# HAY CREEK VALLEY

## FINAL DRAINAGE REPORT

EPC STORMWATER REVIEW COMMENTS  
IN ORANGE BOXES WITH BLACK TEXT

Project No. 22.886.076

DP-15 - Q100

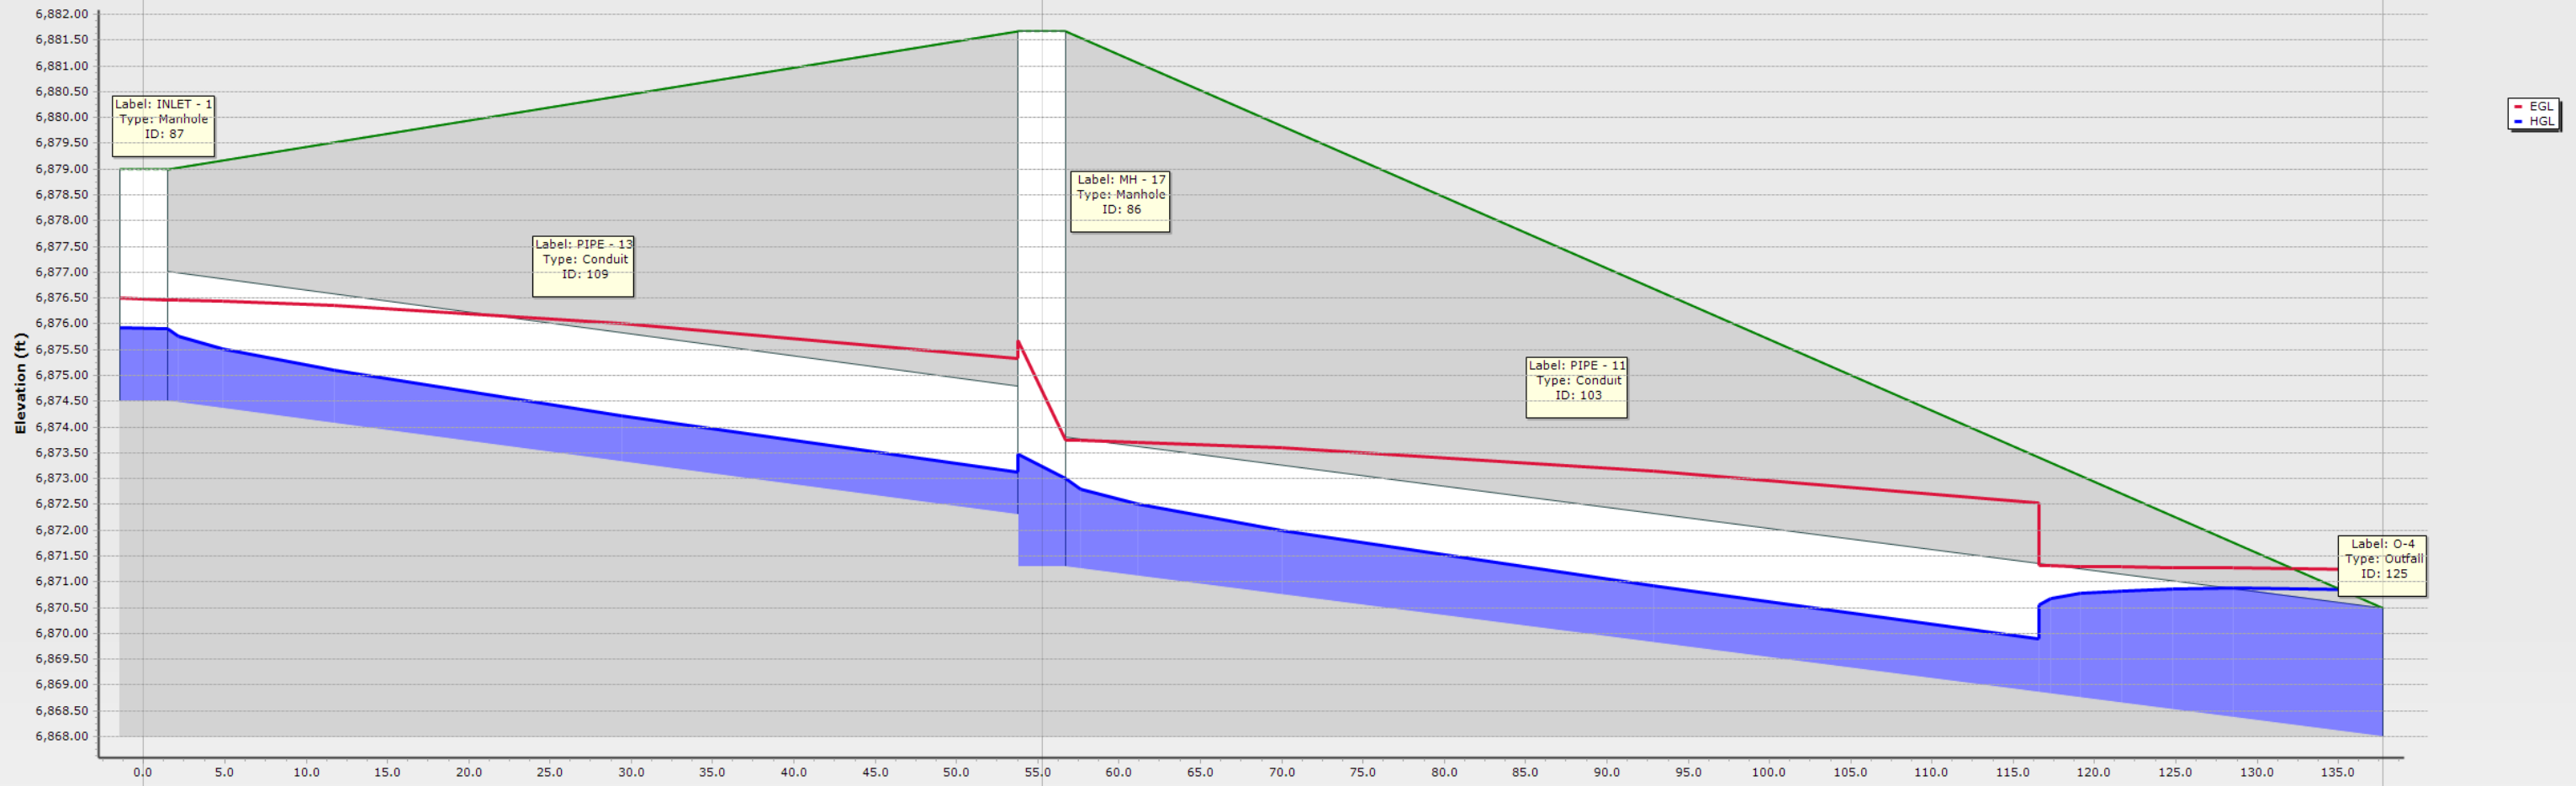
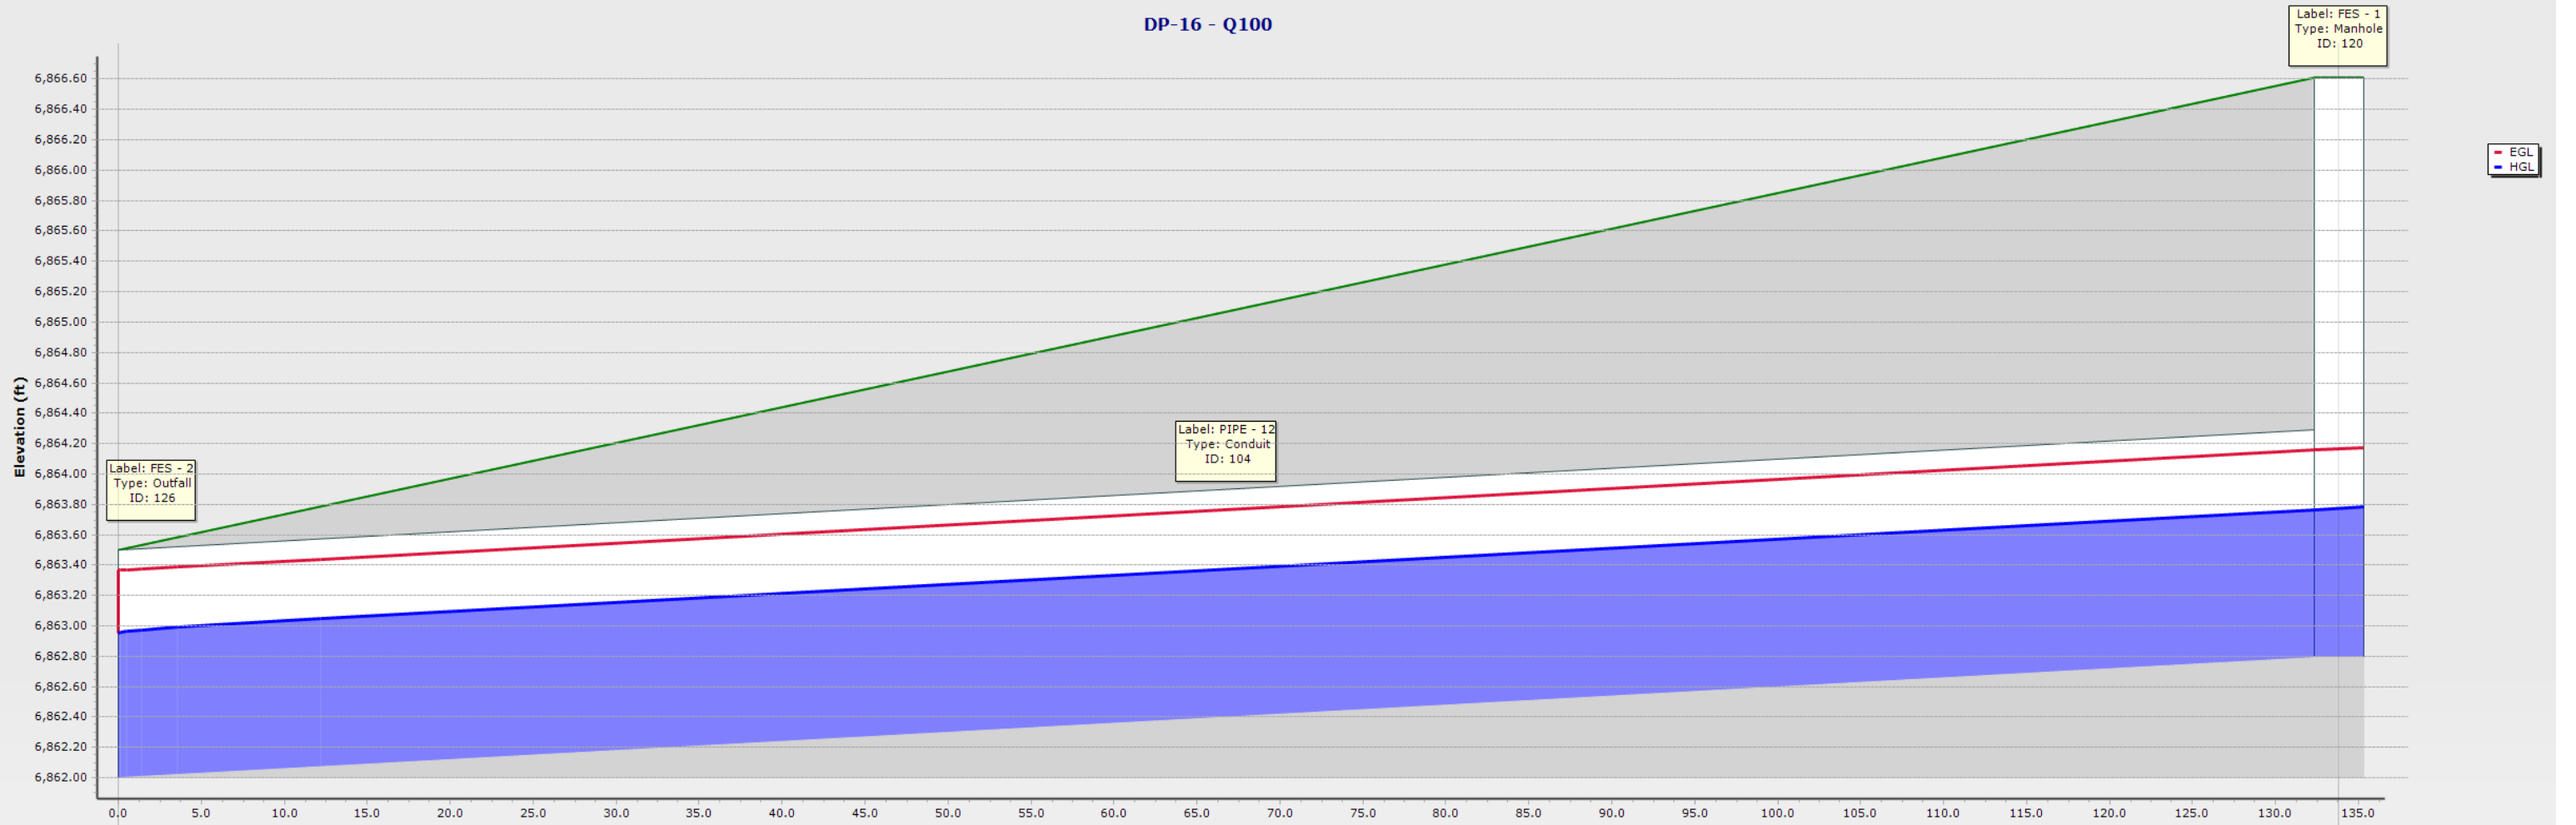
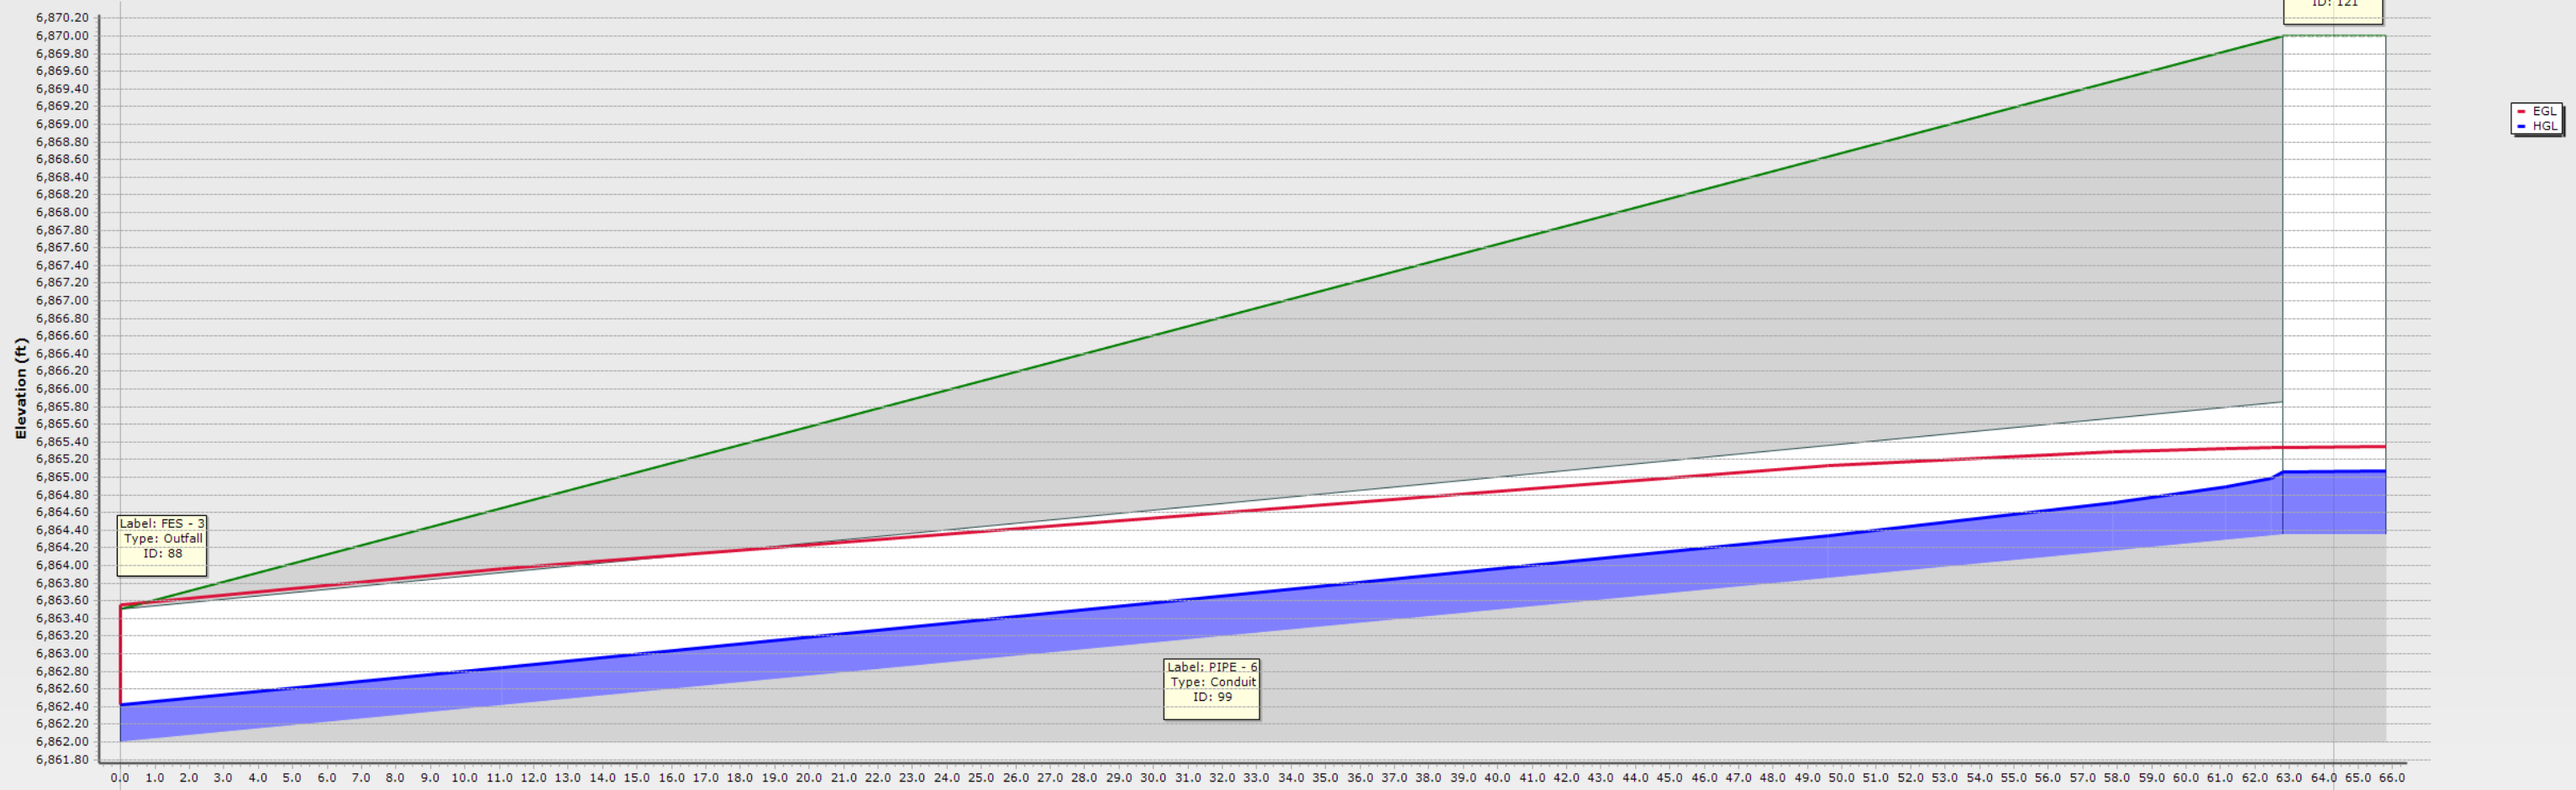
why is free outfall selected and tailwater is not analyzed for 6 of the 7 storm drain outfalls? If there's a reason please add a note/discuss.
